Access Compliance Report Public Rights-of-Way (Pedestrian Signals)

Main Street: CECIL_PASTURE_RD Cross Street: CROWN_VALLEY_PKWY Location: SE

ADA ID: SGRK211026121418 Signal Type: One Push Button-Non APS Overall Compliance: No Severity Scores: BTN 1: 35 BTN 2: N/A No BTN: N/A

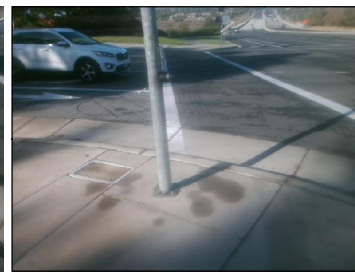
Possible Solutions: Replace Signal Push Button With APS Button. Remove and Replace Clear Space.
